Access Compliance Report

Public Rights-of-Way

(Curb Ramps)

Intersection ID: 28030	Main Street: CHEVIS_CT	Cross Street: LEGACY_CR	Location: NW
ADA ID: 328C3EB0EF77	Ramp Type: Perp	Initial Pass/Fail: Fail	Overall Compliance: No
Severity Score: 1.25			
Codes/Mitigation Info/Possible Solution		Field Measurements/Component Compliance

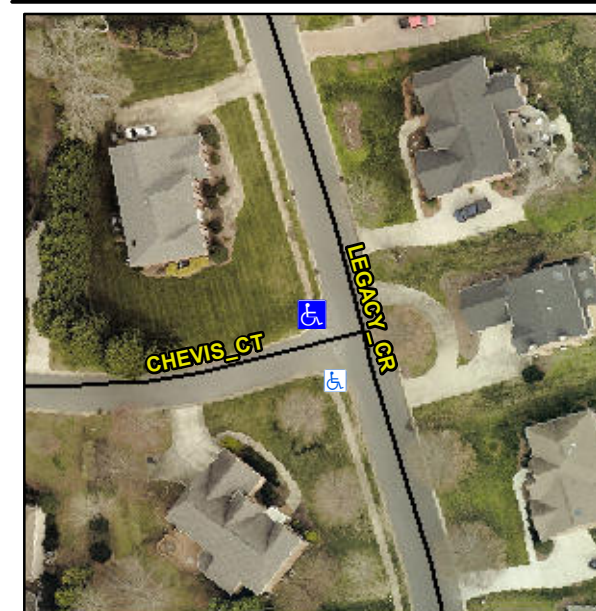
Not Found, R304.5.3

Compliance	Description	Data	Compliance	Description	Data
N/A	Ramp Length (in)	50.0	Yes	Ramp Slope (%)	6.3
Yes	Ramp Width (in)	48.0	No	Ramp XSlope (%)	4.1
N/A	Flare Type LT	N/A	N/A	Flare Type RT	N/A
N/A	Flare Slope LT (%)	N/A	N/A	Flare Slope RT (%)	N/A
N/A	Flare Traversable LT?	N/A	N/A	Flare Traversable RT?	N/A
N/A	Landing Length (in)	N/A	N/A	DWS Provided?	N/A
N/A	Landing Width (in)	N/A	N/A	DWS Contrast?	N/A
N/A	Landing Slope (%)	N/A	N/A	DWS Length (in)	N/A
N/A	Landing X Slope (%)	N/A	N/A	DWS Full Width?	N/A
N/A	Landing Curb? (Y/N)	N/A	N/A	DWS Offset (in)	N/A
N/A	Shared Landing?	N/A			
N/A	Gutter Ponding?	N/A	N/A	Gutter Slope (%)	N/A
N/A	Gutter Lip Ht (in)	N/A	N/A	Gutter X Slope (%)	N/A
N/A	Painted X Walk1?	No	N/A	Painted X Walk2?	N/A
	X Walk 1 Direction	To S		X Walk 2 Direction	N/A
N/A	X Walk 1 Width (in)	N/A	N/A	X Walk 2 Width (in)	N/A
	X Walk 1 Slope (%)	3.1		X Walk 2 Slope (%)	N/A
	X Walk 1 X Slope (%)	1.4		X Walk 2 X Slope (%)	N/A

Remove & Replace Entire Ramp.
